# Access Compliance Report

## Public Rights-of-Way

### (Curb Ramps)

Intersection ID: 49255	Main Street: HOPKINS_ST	Cross Street: OAKBURN_DR	Location: SE
ADA ID: 48F2B8E9E298	Ramp Type: PerpDiag	Initial Pass/Fail: Fail	Overall Compliance: No
Severity Score: 58.75			
Codes/Mitigation Info/Possible Solution		Field Measurements/Component Compliance

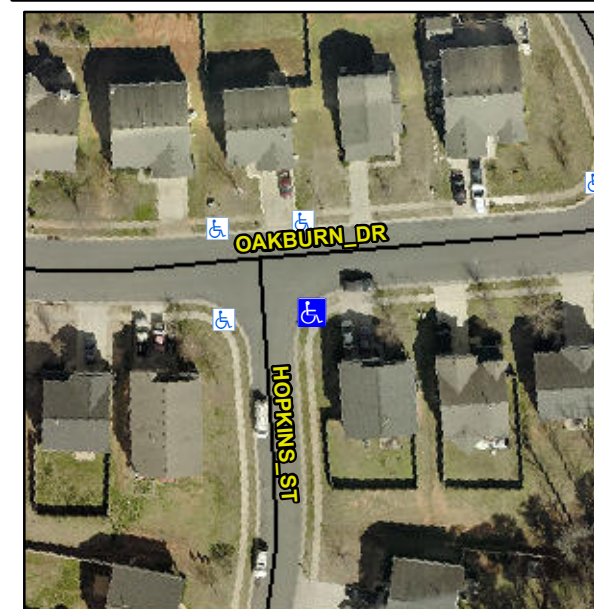
**Not Found, R304.5.1, R304.2.2, R304.5.3**

Compliance	Description	Data	Compliance	Description	Data
N/A	Ramp Length (in)	47.0	No	Ramp Slope (%)	17.2
No	Ramp Width (in)	46.0	No	Ramp XSlope (%)	7.6
N/A	Flare Type LT	N/A	N/A	Flare Type RT	N/A
N/A	Flare Slope LT (%)	N/A	N/A	Flare Slope RT (%)	N/A
N/A	Flare Traversable LT?	N/A	N/A	Flare Traversable RT?	N/A
N/A	Landing Length (in)	N/A	N/A	DWS Provided?	N/A
N/A	Landing Width (in)	N/A	N/A	DWS Contrast?	N/A
N/A	Landing Slope (%)	N/A	N/A	DWS Length (in)	N/A
N/A	Landing X Slope (%)	N/A	N/A	DWS Full Width?	N/A
N/A	Landing Curb? (Y/N)	N/A	N/A	DWS Offset (in)	N/A
N/A	Shared Landing?	N/A			
N/A	Gutter Ponding?	N/A	N/A	Gutter Slope (%)	N/A
N/A	Gutter Lip Ht (in)	N/A	N/A	Gutter X Slope (%)	N/A
N/A	Painted X Walk1?	No	N/A	Painted X Walk2?	No
	X Walk 1 Direction	To N		X Walk 2 Direction	To W
N/A	X Walk 1 Width (in)	N/A	N/A	X Walk 2 Width (in)	N/A
	X Walk 1 Slope (%)	3.6		X Walk 2 Slope (%)	4.0
	X Walk 1 X Slope (%)	3.9		X Walk 2 X Slope (%)	10.1

N/A	Ramp inside XWalk1?	N/A	N/A	Ramp inside XWalk2?	N/A
	Road Slope (%)	8.8	N/A	Clear Space?	N/A
	Road X Slope (%)	1.4	N/A	Clear Space to XWalk (in)	N/A
N/A	Any Obstructions?	N/A	N/A	Storm Grate/Utility Hazard?	N/A
	Obstruction Type			Storm Grate/Utility Type	
		N/A			N/A
			Yes	Surface Condition? (G/P)	Good

**Remove & Replace Curb Ramp With Two New Directional Ramps or Equivalent.**
